GROUP	MODEL
ELE	2022MY EV6 (CV)
NUMBER	DATE
276 (Rev 3, 02/08/2023)	December 2022

TECHNICAL SERVICE BULLETIN

SERVICE ACTION: EXTERNAL AMP REPLACEMENT FOR NOISE/NO SOUND ISSUES (SA520)

External Amplifier

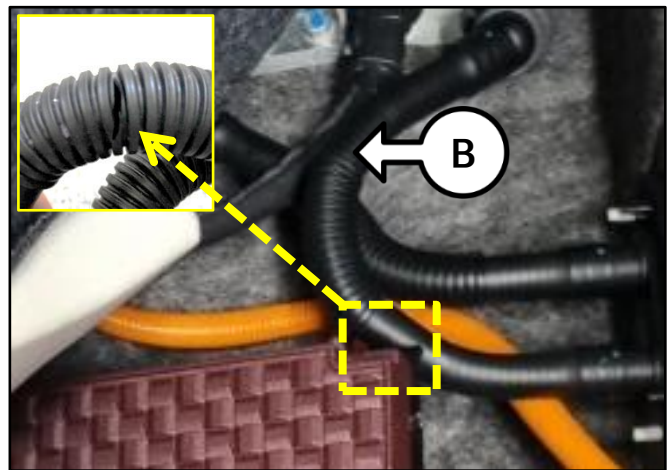
This bulletin provides the procedure to replace the external amplifier on some 2022MY EV6 (CV) vehicles produced from November 17, 2021 through January 7, 2022, that may exhibit symptoms of "noise", "no sound", "intermittent noise", and/or "intermittent no sound". Follow the procedure outlined in this publication to replace the external amplifier. If the vehicle does not exhibit the symptoms, the external amplifier still needs to be replaced if it is included in the list of affected VINs. Before conducting the procedure, verify that the vehicle is included in the list of affected VINs.

1. Replace the External AMP (A) by referring to "Body Electrical System → Audio/AVNT System → External AMP → Removal and Installation" in the applicable Shop Manual on KGIS.

CAUTION
Make sure to not damage the coolant hose (B) during the removal/installation of the External AMP (A).
